PROJECT NARRATIVE
FOR THE ADDITION OF STORAGE UNITS AT 591 25 ROAD
GRAND JUNCTION, COLORADO

REVIEW COMMENTS

TITLE HEADING: Site Plan Review - Storage Units

Review Comments
on
591 25 Road Storage Units
July 8, 1993

SITE PLAN
SCALE: 1" = 20'

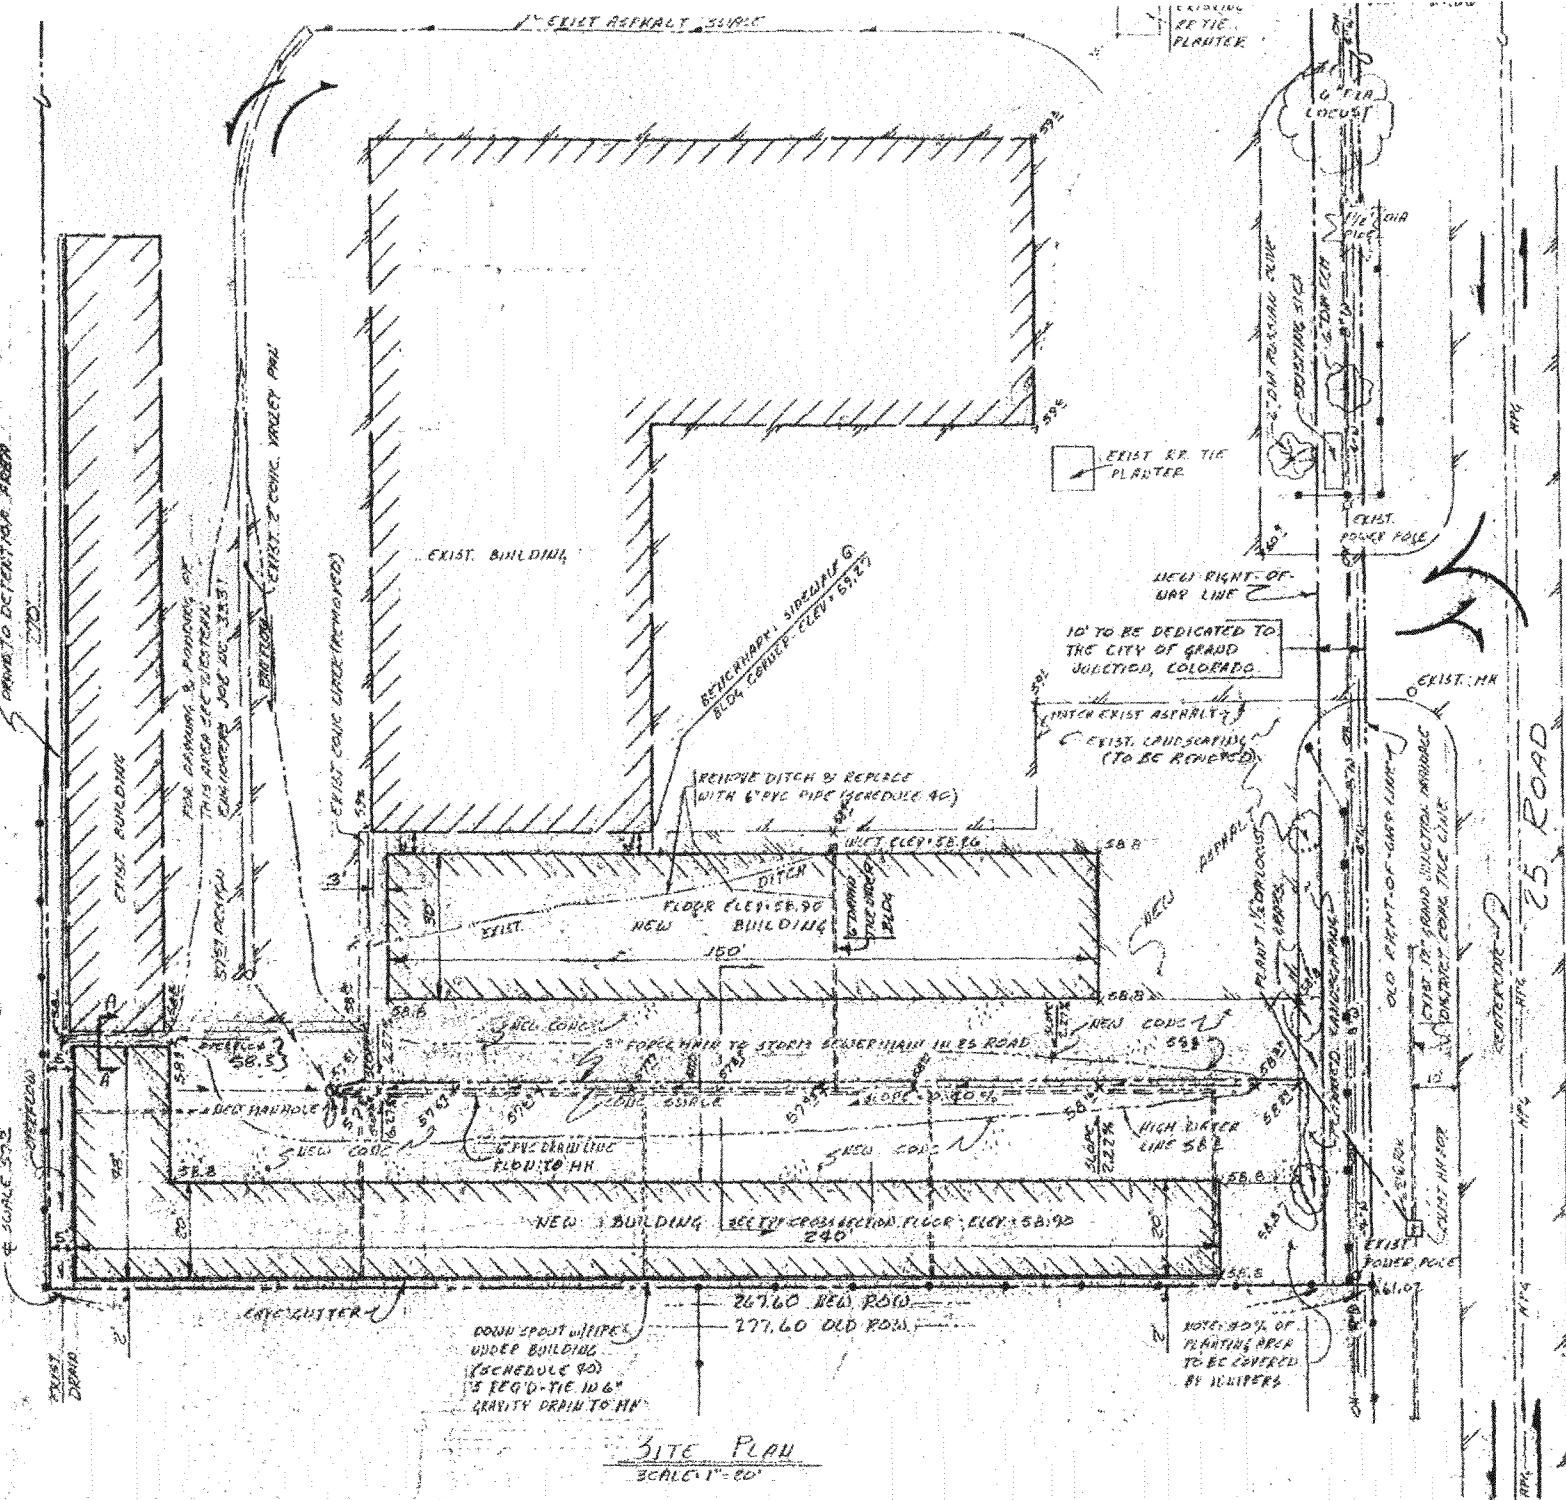
1. Property line around the entire property must be shown on the site plan.

1. The proposed pump capacity, which matches the drainage calculations for outflow and storage volume, is 120 gpm. With a 2 inch force main, 57 feet of frictional head is generated. Adding elevation head, the total head at which the pump will operate is 60 +/- feet of head. Most sump pumps do not operate at that head range. Please provide pump curves, data, and other pertinent information to show that the system will work.

2. Stormwater contains a lot of sediment. Either provide at least 1.0 foot depth below the sump for sedimentation, or taper the bottom of the chamber floor to the pump and use a grit pump.

3. Note the minimum seating head for the valve, which will be the difference in elevation between the high point in the force main to the valve elevation.

4. Provide the grate, manhole bottom, and inflow and outflow pipeline invert elevations.
5. Add slope information on the typical cross-section.
6. $Q_{100h} = 0.5$ cfs, but the pumping rate is Q_{2h} , or 0.26 cfs (or at least is designed for such - see note 1). This means that an additional 0.24 cfs may be discharged from the site under 100-year runoff conditions. However, unless the proposed roof rain gutters, downspouts, and under building discharge lines are adequate, gutter overflow will exceed the 0.24 cfs. Calculate requirements for these facilities, and provide calculations and show/call out proposed facilities (such as several downspouts in lieu of the one per building shown).

7. Tie in shall be per Drainage District requirements, and proof of their approval must be provided.
8. Show existing utilities, if any, in the area of the proposed force main.

9. Call for asphalt replacement.
10. What is the roadway and approximate pipe elevation at tie-in?

11. Provide more grades for asphalt, and the two concrete corners that are without grades.
12. Call out asphalt, concrete, and base course thickness.
13. Call out swale width.
14. Provide drain pipe inverts and slopes. Also, is 4" adequate for runoff? What about PVC under the building? Will the pipe interfere with foundations? Please address.
15. Plug the line from the manhole to the sanitary sewer.
16. The slope of the invert is 0.2% which is very flat. Can this be improved?
7. Provide as-built information.
18. Provide north arrow; scale; total acreage; roof, asphalt, and landscaping acreage; and spaces for Engineering and Community Development signature, date, and title per SSID checklists.
